AGENDA
VILLAGE OF SUSSEX
PLAN COMMISSION MEETING
6:30 PM TUESDAY, OCTOBER 18, 2022
SUSSEX CIVIC CENTER – BOARD ROOM 2nd FLOOR
N64W23760 MAIN STREET

TO: Plan Commission
FROM: Gabe Gilbertson, Community Development Director
RE: Plan Commission meeting of October 18, 2022
DATE: October 13, 2022

VISTA RUN III

SHEET 1 OF 4

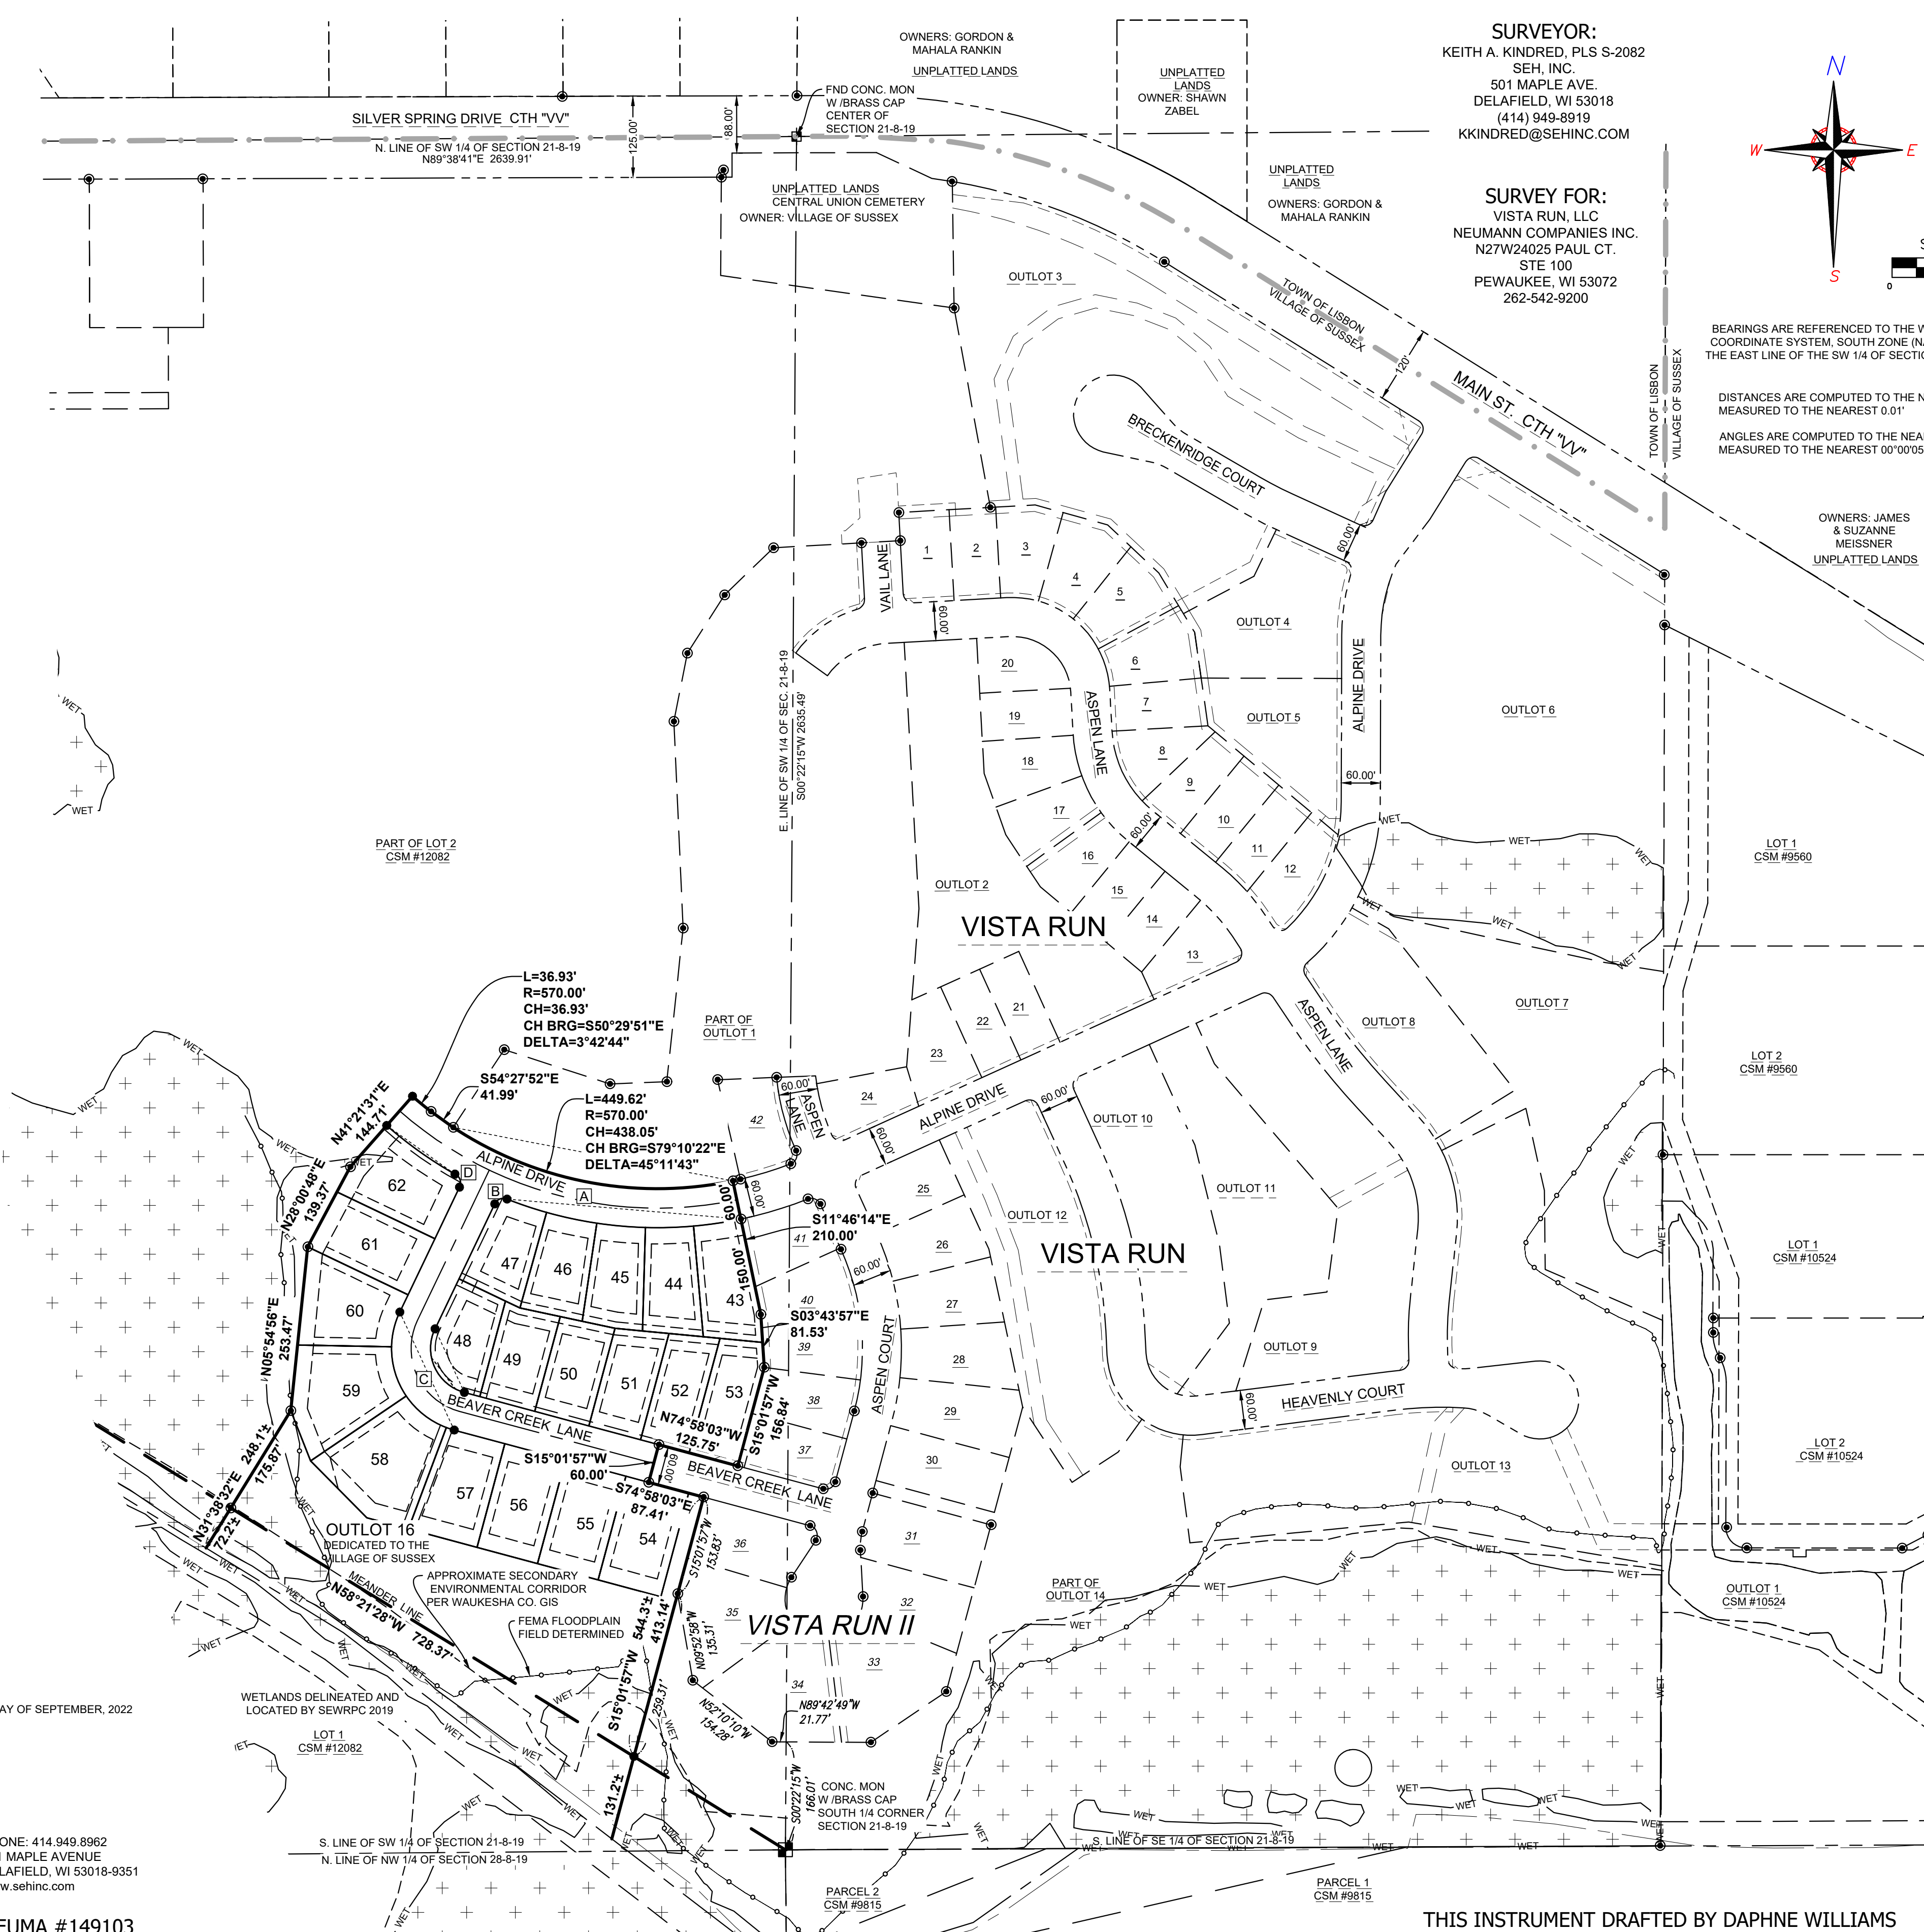
4. On sheet 4 of 4, Jennifer Moore is Treasurer and Clerk and will sign the Village Board, Plan Commission and Village Treasurer certificates (not Jeremy Smith and Nancy Whalen).

VISTA RUN III

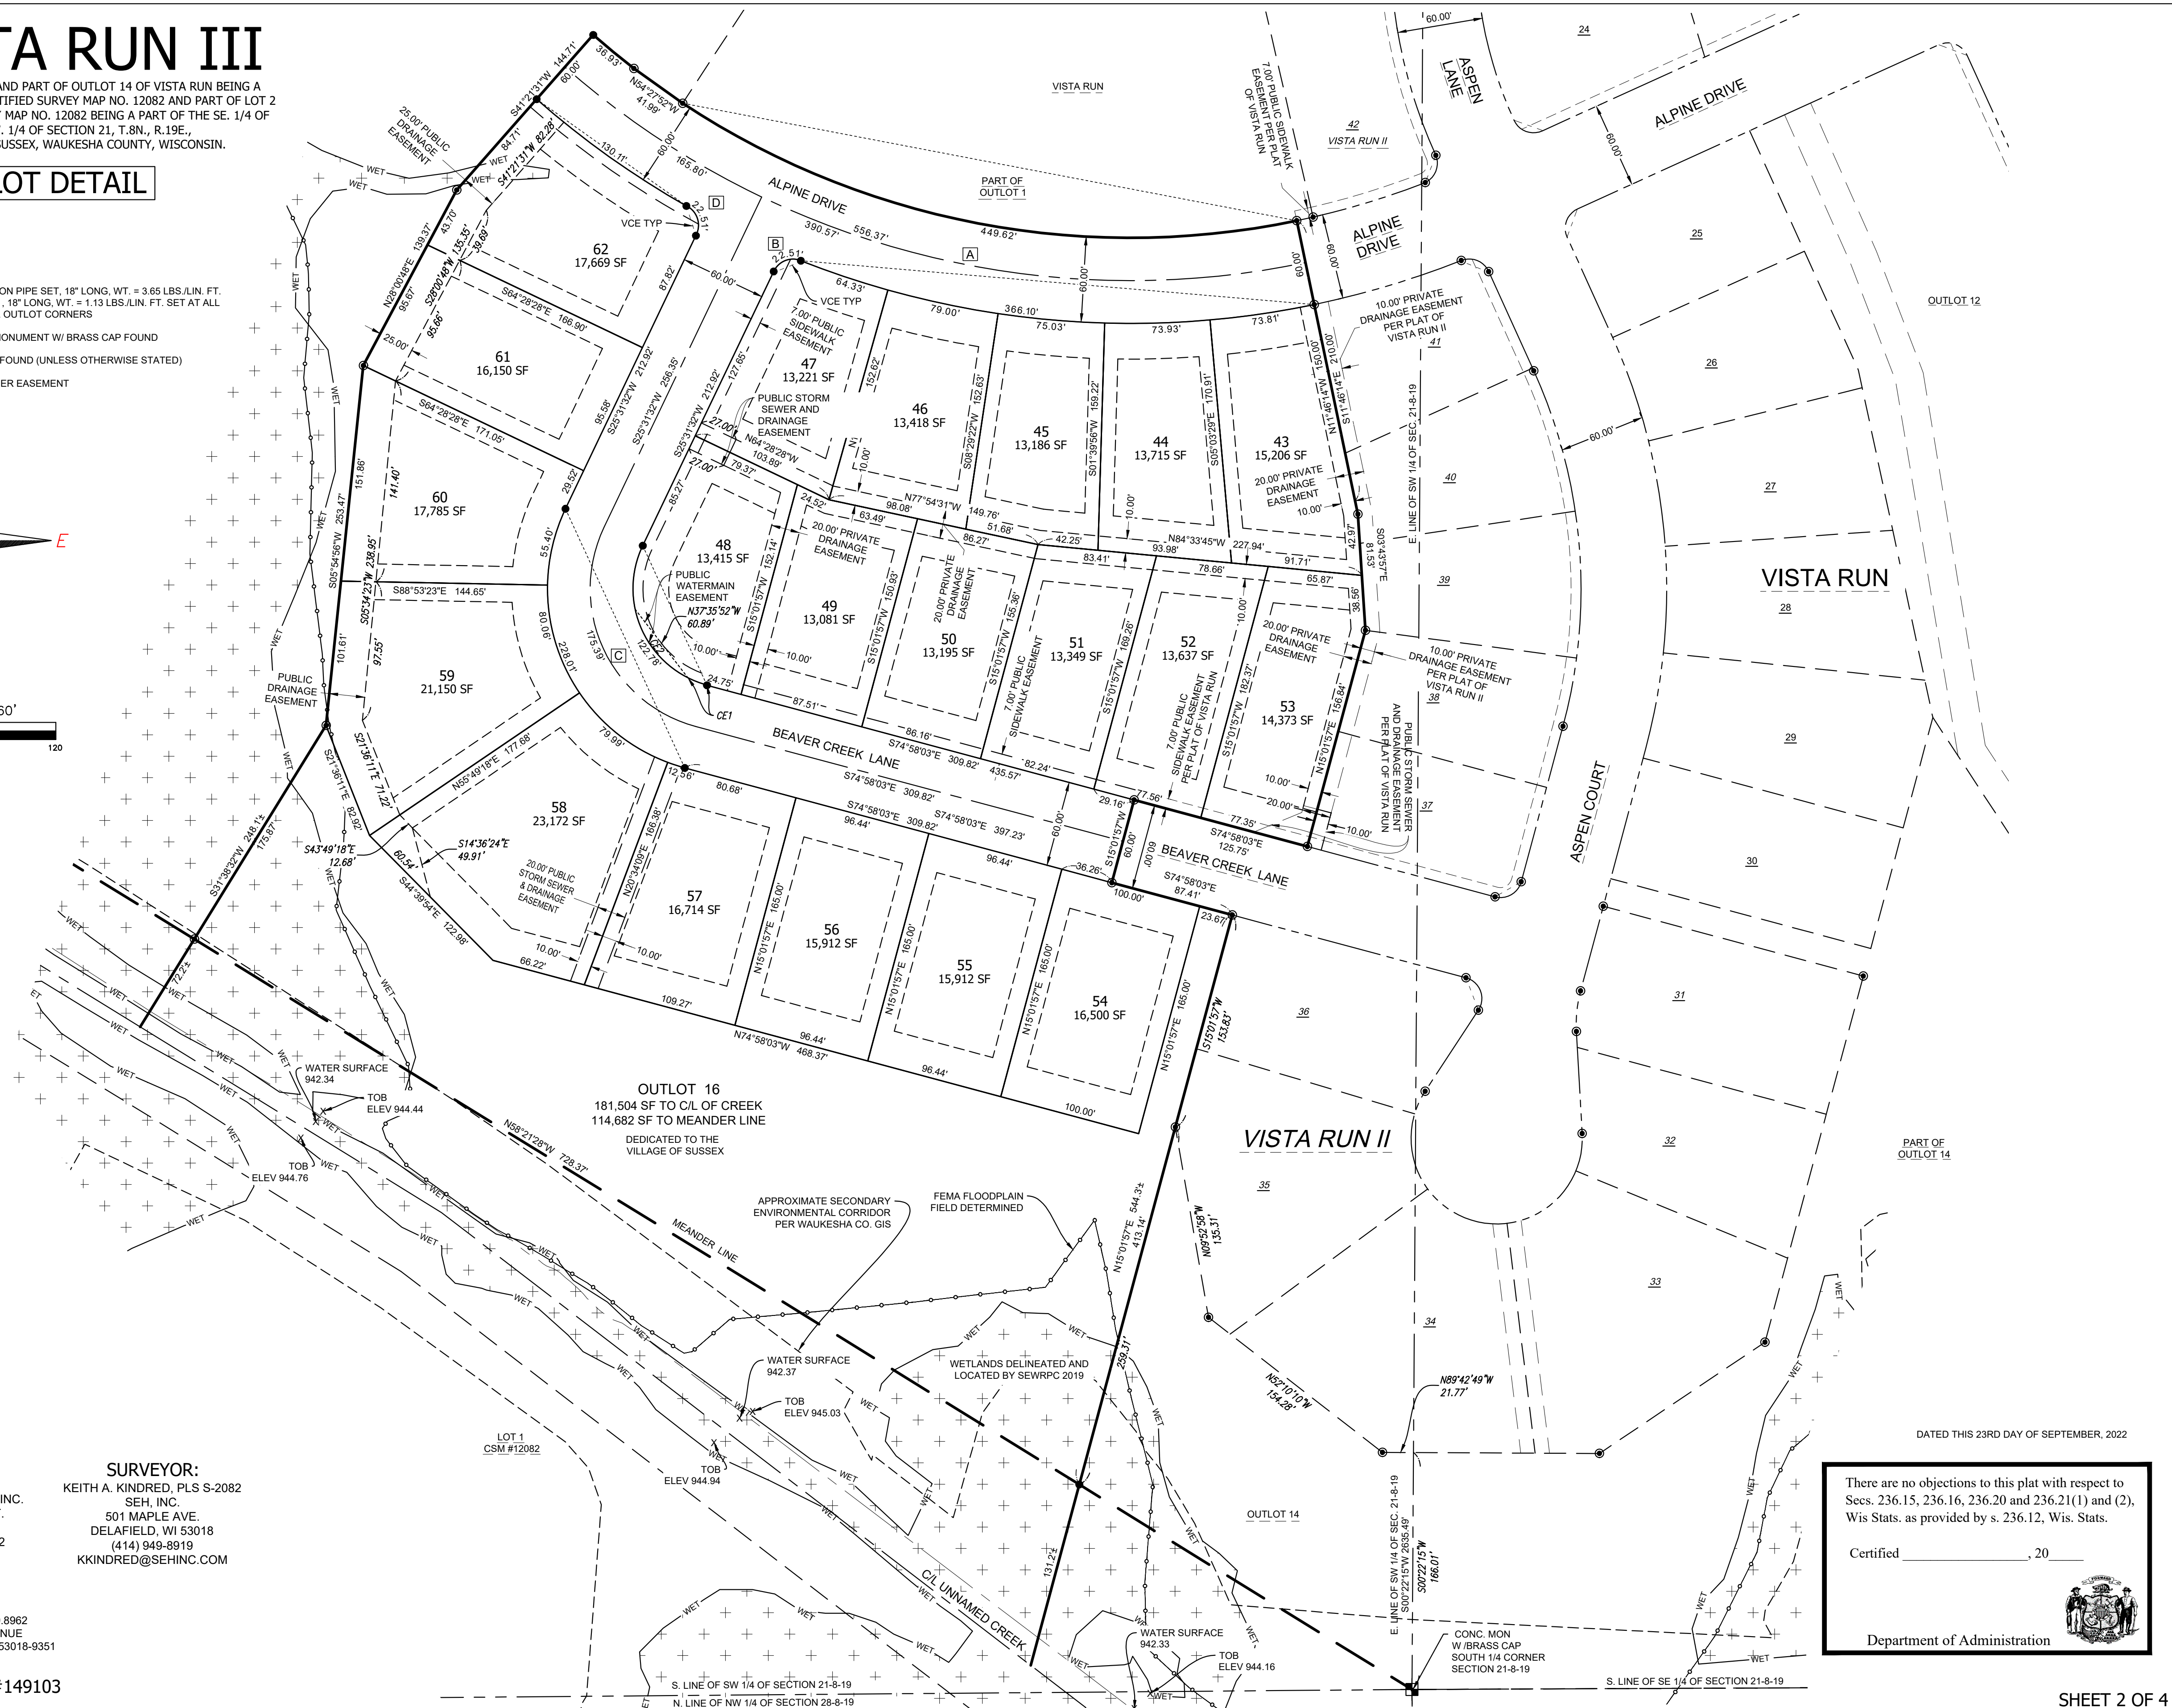
7. The We Energies utility easements must be added to the plat.
8. Add a description of how the FEMA floodplain was determined to the note depicting the floodplain on sheet 2 of 4.

13. Private Drainage Easements – these easements should be granted to the owners in previous subdivisions as well (for example, lots 37 – 41 of Vista Run II).
14. Please label the Point of Beginning of your legal description on sheet 2 of 4.
15. Per 236.20(4)(b) please add a note or notes that the roads are Dedicated to the Public.
